**Final**  
**CEQA Addendum**

**City of Pleasanton**  
**Recycled Water Project**

**SCH #2014062084**

**Figure 1 Proposed Pipeline Alignment Changes**

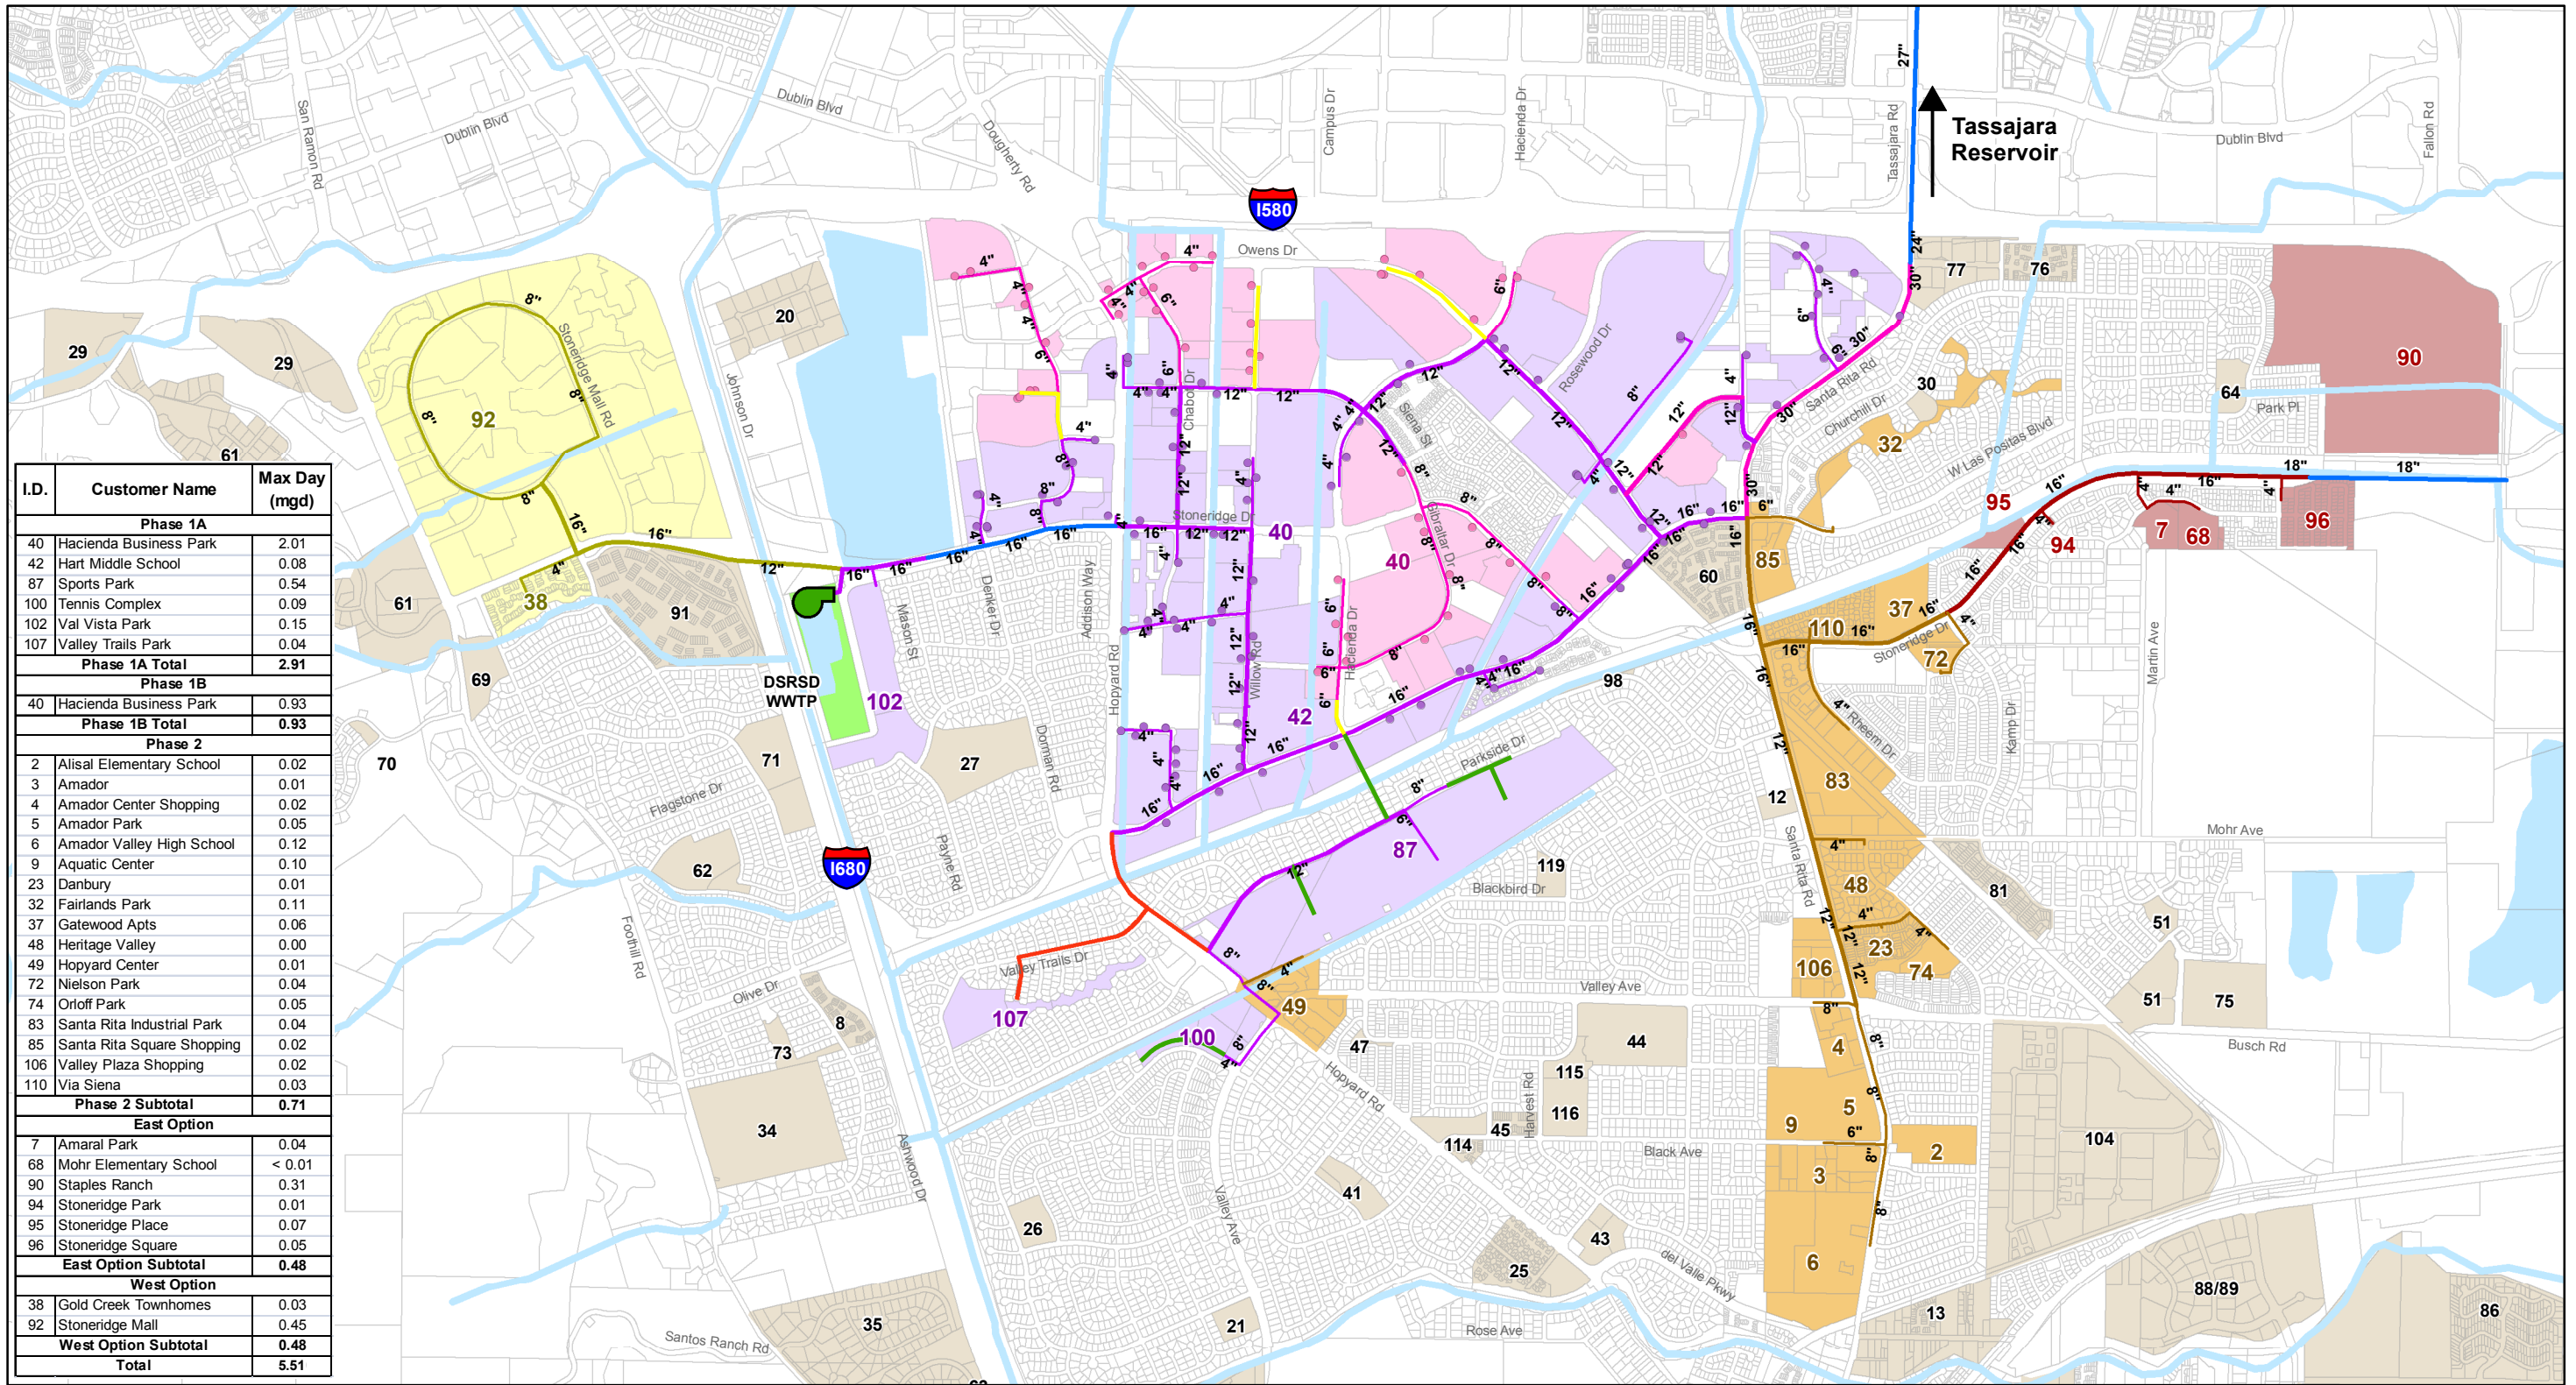
Since the IS/MND was adopted on September 16, 2014, the City is considering changing portions of the alignment to better coincide with design efficiencies. As a result and as shown on Table 2 below, the proposed alignment changes would result in an overall addition of 720 feet or 0.1 miles of new pipeline. In addition, the Proposed Changed Project would result in repurposing an additional 9,850 feet or 1.9 miles of existing pipelines, resulting in approximately 10,570 feet or 2.0 miles of new and repurposed pipeline. Figure 1 also shows those changes graphically on the project map. No other changes are contemplated at this time or will be covered under this addendum.

The addendum proposes repurposing an additional 10,150 feet of existing pipeline at Dublin Boulevard & Fallon Road. Please provide project graphics showing where the proposed new work would intersect Caltrans right-of-way. The entire project footprint including staging and access should also be identified.

*Comment A-1.* Thank you for your comments. As indicated in the April 9, 2015 e-mail (with attached maps and graphics) from Rita Di Candia, Water Conservation Manager for the City of Pleasanton to Sherie George of your department, the Proposed Project will not take place in Caltrans' right-of-way at Dublin Boulevard and Fallon Road. Also, please refer to our responses to your comments on the Public Draft IS/MND in the Final IS/MND that was sent to Luis Melendez of your staff on September 8, 2014 and which still provides applicable responses to those comments.
